APPENDIX J

City of Madison Coordination

Subject: Staff Comments on North Stoughton Rd Design Alternatives, version 3. With Transportation Commission Comments

Subject: WisDOT
North Stoughton Road Project
City of Madison Staff Comments

Concept 1

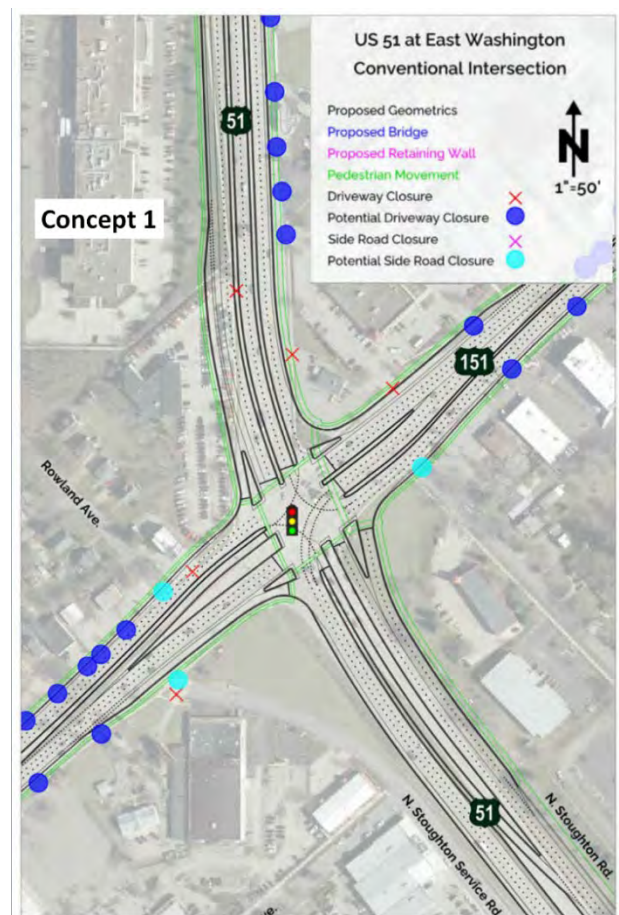
The existing Stoughton Rd and East Washington Ave intersection is poor with long crossing distances for pedestrians and bicycles. The proposed concept is similar to what exists with similar numbers of lanes. While poor, Concept 1's at-grade crossing is perhaps better and more urban than many of the concepts that have been presented.

This concept has relatively straight forward pedestrian and bicycle paths. Crossing distances are slightly longer due to increased island size. With the high volumes on both East Washington Ave and Stoughton Rd, it is important that pedestrians are able to cross each approach in a single phase, without having to use an island as a refuge. We encourage WisDOT to reconsider the need for the SBRT and EBRT slip lanes at East Washington & Stoughton Road. These slip lanes add complexity and delay to the pedestrian crossing.

We also encourage WisDOT to maintain some type of access between the North Stoughton Service Road and East Washington Ave.

The concept has up to three potential side road closures due to policy reasons. Because this access loss is policy rather than a geometric necessity, and these side road access have existed for decades as right-in/right-out driveways, staff recommend that these accesses be preserved.

This concept has numerous potential access removals, again for policy reasons rather than geometric. The loss of these access points would result in numerous relocations and require that land remain vacant for lack of access. As with street access, staff recommend that these accesses be preserved as right-in/right-out.

As mentioned, if potential access closures occur it would result in numerous relocations. Staff recommend these accesses be preserved. This would allow both preservation of uses and future redevelopment in most quadrants of the intersection.

Concept 2

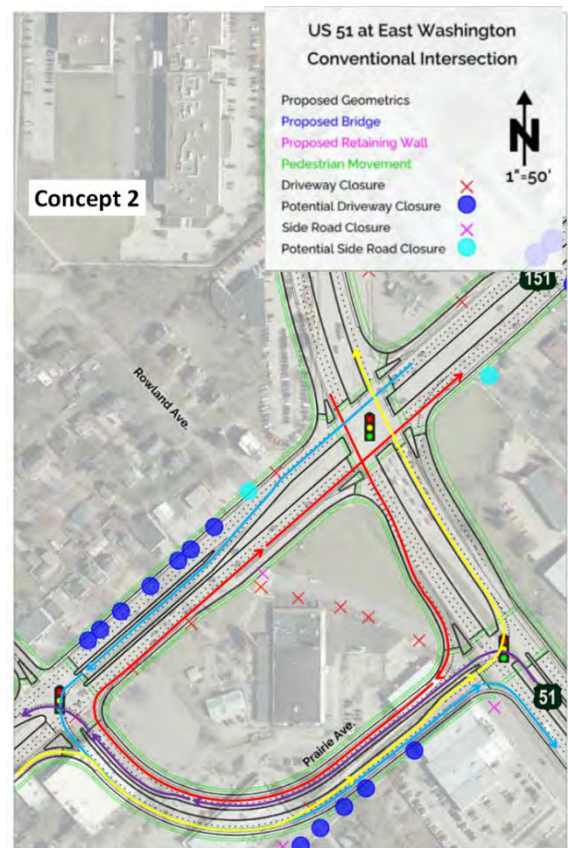
This concept, while adding one intersection to East Washington, reduces the size of the Stoughton Road/East Washington Ave intersection and keeps all movements at one level.

This concept has relatively straightforward pedestrian and bicycle paths. Crossing distances could be shorter due to reduced number of lanes that need to be crossed. We would encourage WisDOT to narrow the very large median islands that increase crossing distances and clearance times. While another intersection is added, the signal timing for both intersections would be more straightforward with fewer turning phases. As mentioned previously, with the high volumes on both East Washington Ave and Stoughton Rd, it is important that pedestrians are able to cross each approach in a single phase, without having to use an island as a refuge.

The concept has up to two potential side road closures due to policy reasons, and a realignment of the North Stoughton Rd Service Road. Because this access loss is policy rather than a geometric necessity, and these side road access have existed for decades as right-in/right-out driveways, staff recommend that these accesses be preserved. Staff also recommend access be allow on Prairie Ave, so that parcel would be available for redevelopment.

This concept has numerous potential access removals, again for policy reasons rather than geometric. As with the previous alternative, staff recommend that these accesses be preserved as right-in/right-out as they have currently existed for decades. It is important for access to be preserved on Prairie Ave so that land parcels on both sides are able to host active land uses.

As mentioned, if potential access closures occur it would result in numerous relocations. Staff recommend these accesses be preserved as right-in/right-out. It is likely portions of the shopping mall in the southwest quadrant could be relocated. It is important that this parcel maintain active uses through the preservation of some type of access. Because this intersection type does not have grade differentials that mandate access closure, there may be more opportunity for active land uses adjacent to the corridor.

Concept 3

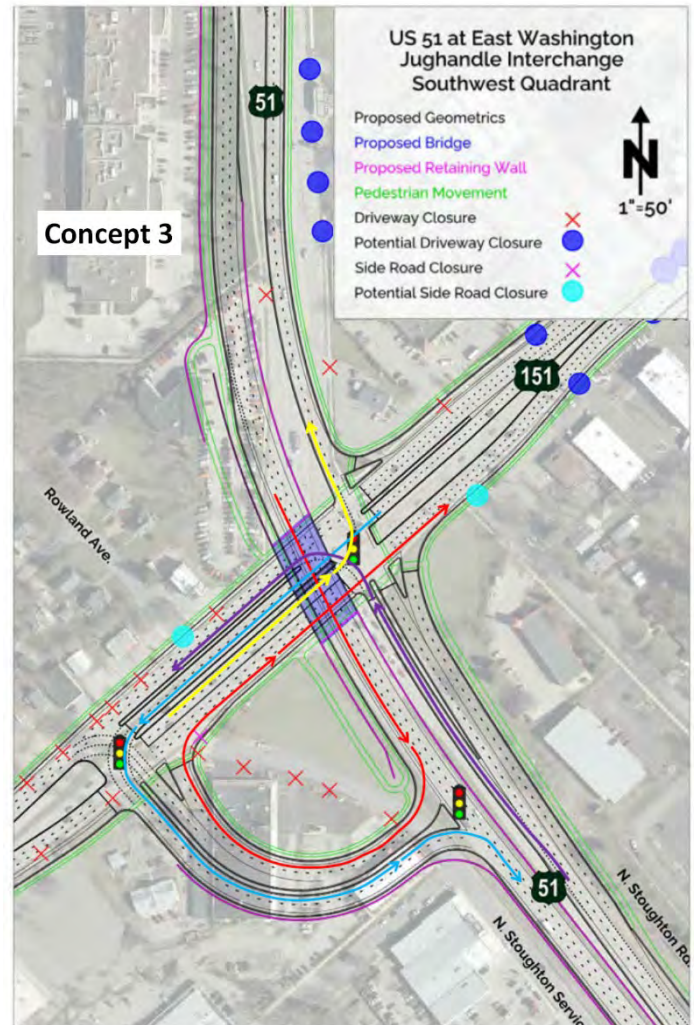
While grade separating one movement, this jughandle still incorporates signals in the northbound, southbound, eastbound and westbound directions. It adds intersection capacity without introducing a freeway interchange. This helps preserve urban speeds, and probably would not encourage speeding between up and downstream signalized intersections.

This concept reduces the number of lanes a pedestrian has to cross in the east-west direction by half, and eliminates many of the conflicting left turns from the signal timing. East-West pedestrian and bicycle routing is straightforward and direct. Extra efforts

are needed to provide pedestrian/bicycle connectivity in the north-south direction on the west side of the intersection. This includes, but is not limited to a signalized crossing on the west side of the jug handle intersection with East Washington. This was accomplished at Junction Rd/Mineral Point Rd through a spiraled path grade separation. The City of Madison recommends improving bike connectivity from neighborhoods south of East Washington to destinations and the Madison bike network north of East Washington.

The concept has up to two potential side road closures due to policy reasons. Again, staff recommends maintaining these sideroad access points as right-in/right-out.

This concept has numerous confirmed access removals. Some of these access removals are necessary due to grade changes, and the southwest quadrant ramp construction. Madison requests WisDOT re-evaluate the listed access removals in the westbound East Washington direction to see if all are necessary. These confirmed access removals would create a strip of relocations, and the ensuing vacant undevelopable land, that is not beneficial.

The access closures in the northeast quadrant would relocate Walgreens, an important area business. Since the grade separated lanes are in the southbound direction, there should be no additional grade challenges with providing access to Walgreens. Measures should be taken to preserve this access and business. Similarly, westbound East Washington Ave would have all accesses removed – resulting in a strip of relocations and corresponding vacant undevelopable land. Yet, there appears to be no great profile differential on East Washington Ave that would mandate these access closures. Staff recommend these accesses be preserved as right-in right-out to the extent possible. The southwest quadrant would be relocated, and there are no alternatives to this relocation. Yet, with the preservation of access, the northeast and southeast quadrants could remain active land uses. The southbound horizontal curve is designed so that it could relocate 3571 Stoughton Road. This building should be preserved.

Concept 4

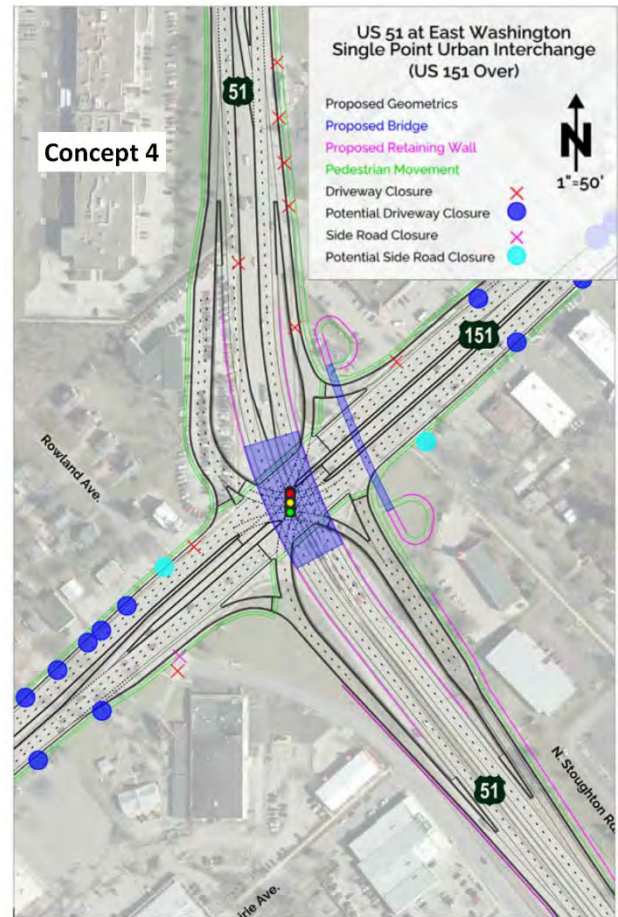
This concept is one of the more impactful concepts. It constructs a freeway interchange between two signalized intersections, which will likely create speeding problems in the urban street section to the north. Examples of where isolated interchanges pose similar challenges exist at Aberg and the at-grade intersections north of this interchange.

This concept technically reduces the number of lanes a pedestrian has to cross in the east-west direction, but there are multiple islands a pedestrian would have to travel through. Single Point Interchanges are very poor for crossings in the grade separated direction because there are no traffic gaps in the turning or through movements. Consequently, this movement must be handled through a grade separated pedestrian crossing. At the Verona Road Interchange, this is handled with a tunnel on the south approach. At the US 51/East Washington interchange, pedestrian crossing would be accommodated on the east approach through a spiraled ramp. No accommodations would be provided on the west approach. There is concern that some pedestrians would cross at-grade in the north-south direction to avoid the indirection of the pedestrian bridge on the east approach, and the total lack of north-south pedestrian accommodations on the west approach. Madison has had poor compliance/usage of the pedestrian bridge similar to this proposal crossing East Washington Ave at Marquette

Pedestrian crossings in the East – West direction would be broken into 4 separate crossings which would add substantial signal delay to the pedestrian crossing. Vulnerable users, such as the visually challenged or young bike riders, would have difficulty traveling through the interchange. The pedestrian crossings of some slip lanes shown may pose a hazard as people crossing on foot often disobey pedestrian signals when the crossing distance is short and delay high.

The concept has up to two potential side road closures due to policy reasons. Again, staff recommends maintaining these sideroad access points as right-in/right-out.

For East Washington, Madison requests WisDOT evaluate the potential access removals in the westbound East Washington direction to see if all are necessary. If realized, these access removals would create a strip of relocations, and the ensuing vacant undevelopable land, that is not beneficial.

Unavoidable access closures in the northeast quadrant would relocate Walgreens, an important area business, and businesses north of Walgreens. Similarly, westbound East Washington Ave would likely have accesses removed because of their proximity to a freeway ramp terminal. This would result in a strip of relocations and corresponding vacant undevelopable land. Staff recommend these accesses be preserved as right-in right-out to the extent possible.

Note: If WisDOT feels that some type of interchange alternative must be brought forward, an alternative to the Single Point Urban Interchange could be a tight diamond interchange with north-south being the dominant direction. Staff had previously provided negative comments to WisDOT regarding a tight diamond, but a tight diamond decreases complexity with pedestrian and bicycle routing.

Concept 5

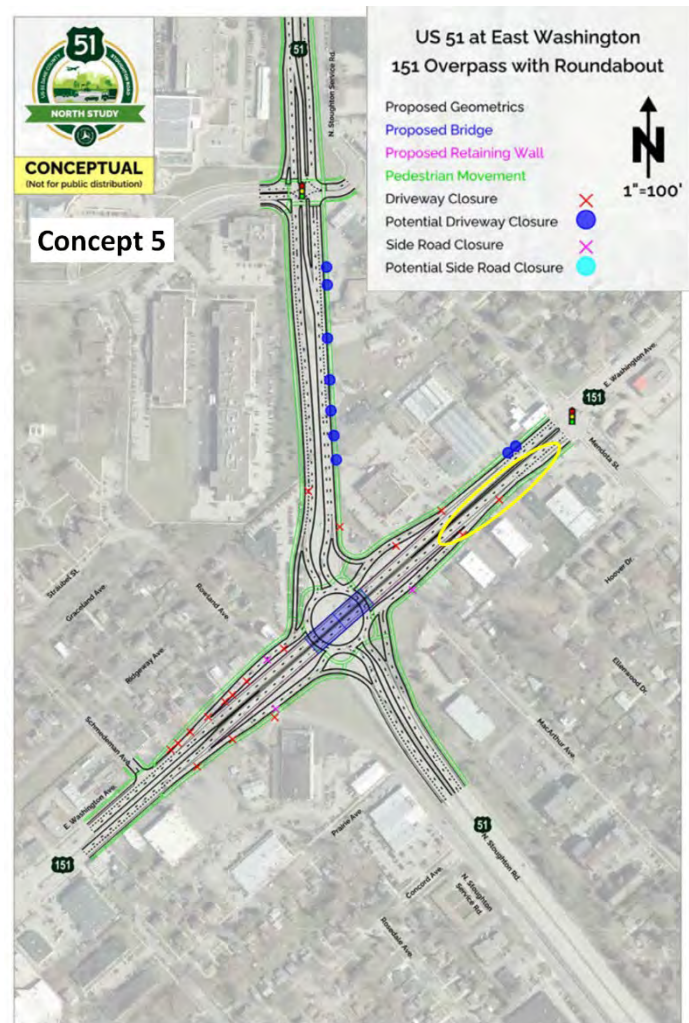
This concept is also one of the more impactful concepts. It constructs a somewhat unconventional interchange with the east-west direction being the dominant direction. The interchange is placed between two signalized intersections on East Washington Ave. This introduces a freeway treatment between two urban intersections. This could encourage speeding between signals on East Washington.

Concept 5 has pedestrians and cyclists cross the intersection at the depressed roundabout level. Pedestrian crossings at roundabouts tend to be indirect, and the roundabout bypass lanes in the intersection accentuate this challenge. North-south crossings would have fewer vehicles and more traffic gaps to cross. East-west pedestrians would have to cross larger traffic volumes without the aid of a traffic signal. Bicycle traffic would have very indirect routing through the interchange unless they chose to take a lane. Because of the bypass lanes, a cyclist would likely need to stop and wait 4 times to travel east-west through the roundabout.

Madison requests WisDOT reconsider the need for slip lanes for the EBRT, SBRT, and WBRT directions. Some may be needed for truck turning radii, but the extent that they can be reduced or eliminated would reduce speeds.

The concept has three confirmed and unavoidable access street closures

For East Washington, Madison requests WisDOT evaluate the potential access removals in the westbound East Washington direction to see if all are necessary. If realized, these access removals would create a strip of relocations, and the ensuing vacant undevelopable land, that is not beneficial.

Unavoidable access closures in the northeast quadrant would relocate Walgreens, an important area business, and businesses north of Walgreens. Similarly, westbound East Washington Ave would likely have accesses removed because of their proximity to a freeway ramp terminal. This would result in a strip of relocations and corresponding vacant undevelopable land. Staff recommend these accesses be preserved as right-in right-out to the extent possible.

Concept 7

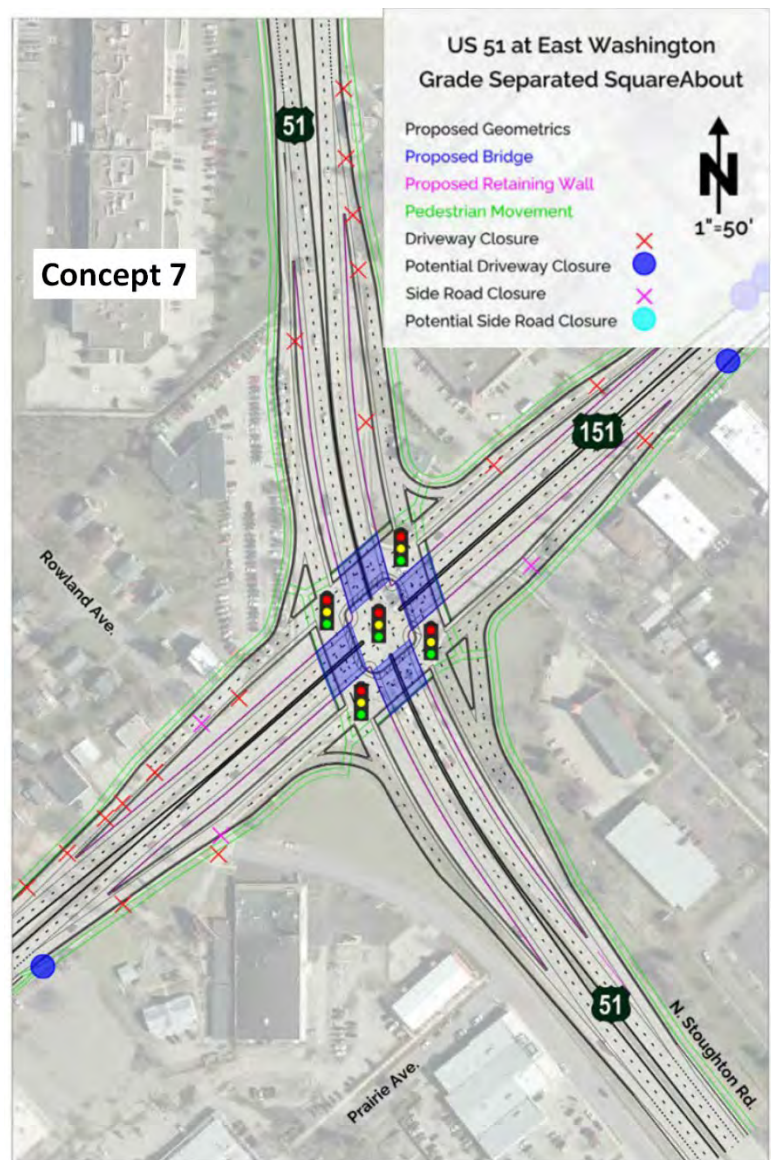
The benefits and impacts of this concept are very similar to Concept 6, except the signalized intersections for turning movements would provide simpler and more direct routes for pedestrians and bicycles. As mentioned with Concept 6, the signalized intersection for through movements could be unexpected for what appears to be an interchange and lead to more crashes.

This concept is also one of the more impactful concepts. It constructs a grade separated intersection between two signalized intersections on East Washington Ave. As mentioned, the signal for through movements would be unexpected, yet would be consistent with up and down stream signals on both East Washington and Stoughton Road.

Concept 7 has pedestrians and cyclists cross the intersection at the raised mini couplet level. The crossings are direct and straight forward, and the short-cycle signal timing would not create a lot of delay. Generally pedestrian crossing with this concept are better than those for Concept 6.

The concept has three confirmed and unavoidable access street closures. Some type of connection (not shown) would be needed for the Stoughton Rd frontage road.

If realized, these access removals would create a strip of relocations, and the ensuing vacant undevelopable land, that is not beneficial.

Unavoidable access closures in the northeast quadrant would relocate Walgreens and businesses north of Walgreens. Similarly, westbound East Washington Ave would likely have accesses removed because of their proximity to a freeway ramp terminal. This would result in a strip of relocations and corresponding vacant undevelopable land. Staff recommend these accesses be preserved as right-in right-out to the extent possible. Grade changes and ramps would prevent access in almost all quadrants, relocating many businesses and preventing new development.

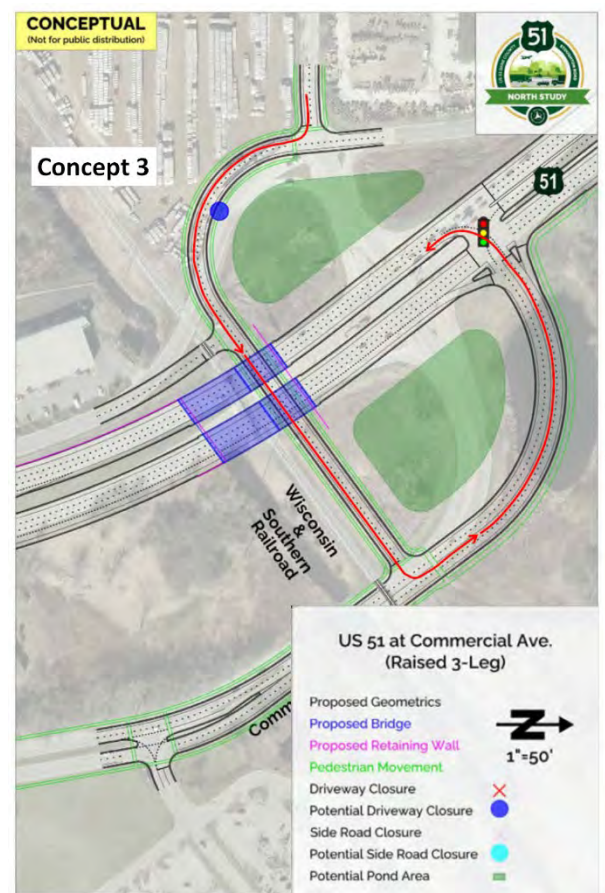
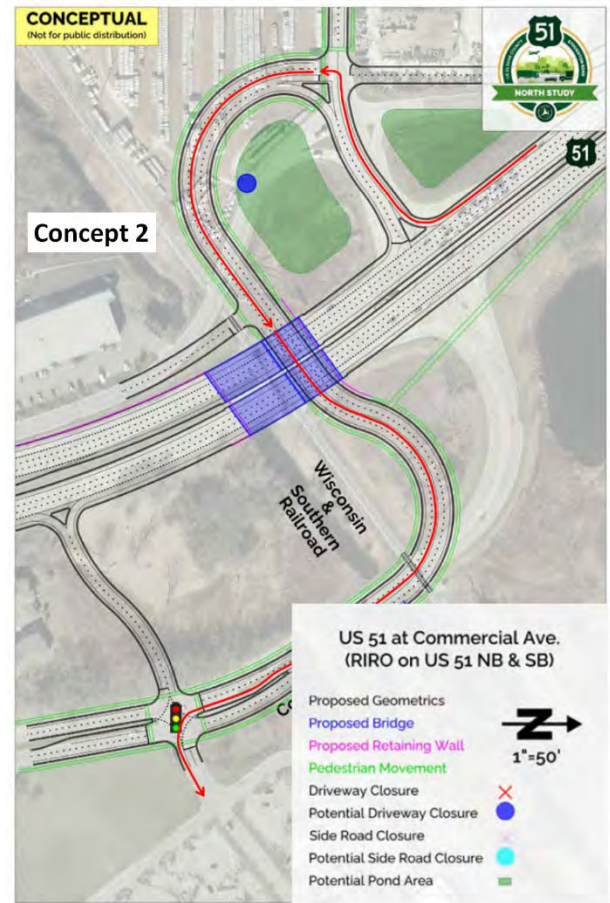
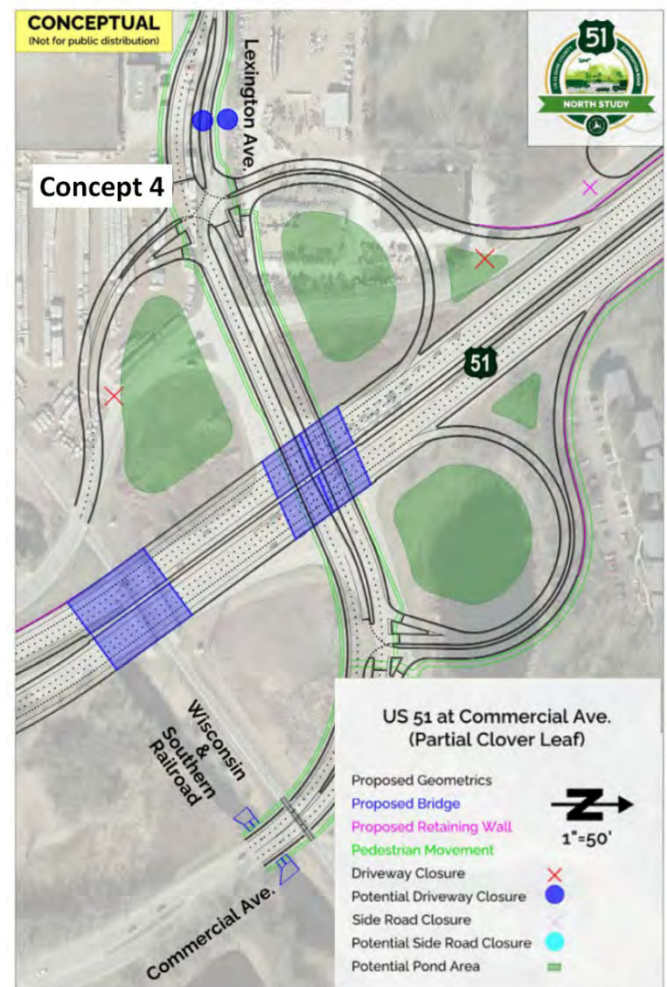
The realignment of the North Stoughton Service road provides very modest throat distance improvements for the impacts generated. Staff recommend revising this portion of the alternative.

Concept 4 places a freeflowing interchange ramps just 0.3 miles from the signalized Highway 30 ramp terminals, and 0.4 miles the signalized East Washington Ave intersection. The freeflowing ramps are contrary to the intersection control both up and down stream and could lead to higher speeds and more severe crashes. Concept 4 also requires two bridges and has greater right of way impacts. Therefore Concept 4 is not recommended.

Concepts 2 and 3 both provide a grade separated WSOR crossing, and therefore could provide benefits if passenger rail is brought to the Madison area. These alternatives also provide a less stressful crossing for pedestrians and cyclists. Staff have no strong preference between concepts.

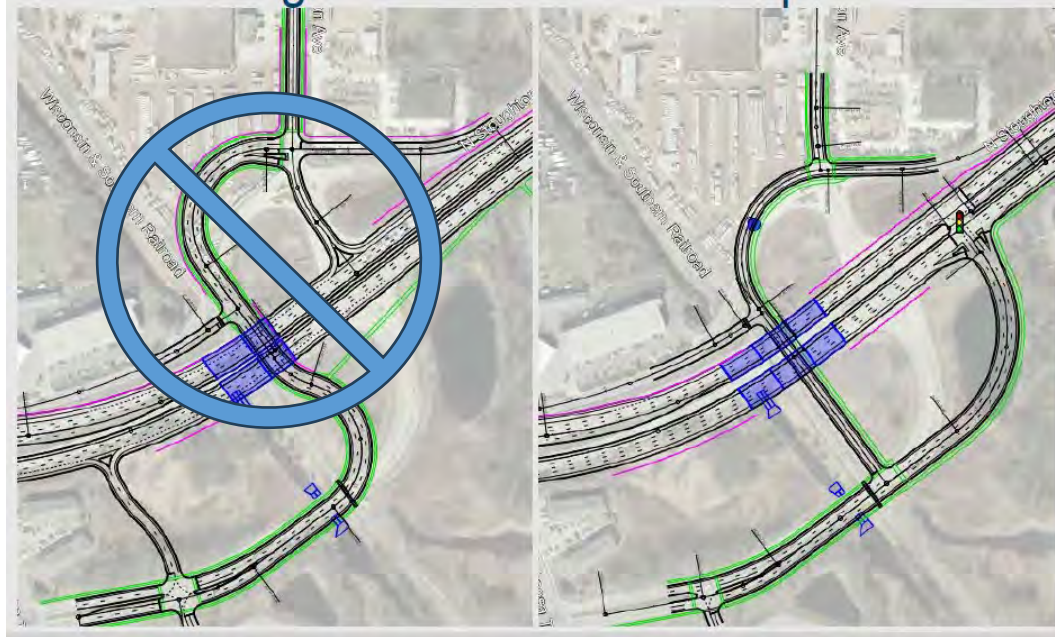
At Highway 30, City staff agree with elimination of tunnel addressing NB weave onto west bound Hwy 30. We have felt this was a rather drastic measure for a common problem.

- Tunnel concept introduced to separate traffic and eliminate weave on US 51 NB (ramp to STH 30 WB)
 - Design completed to restrict urge to complete weave due to very short distance and available use of tunnel

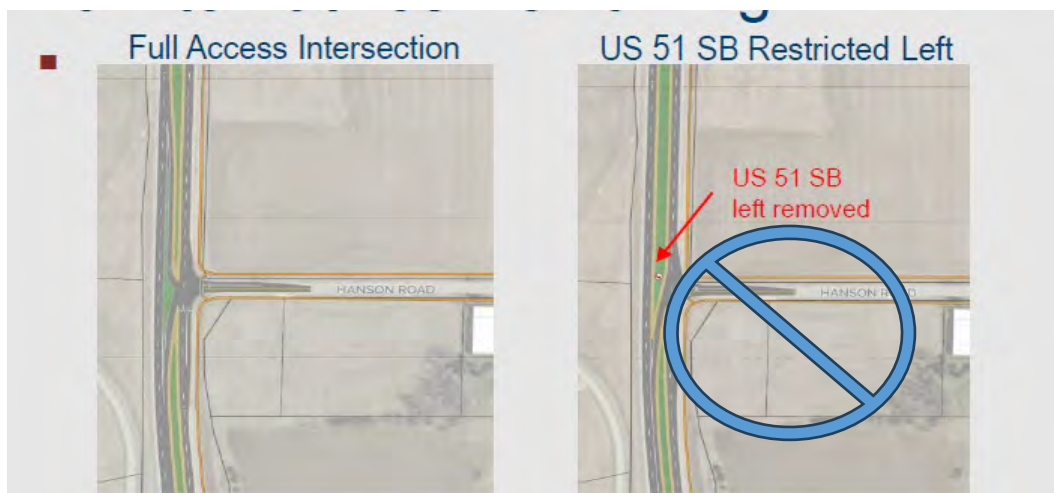
At Commercial Ave - City staff agree with eliminating the right in/right out jug handle from consideration.
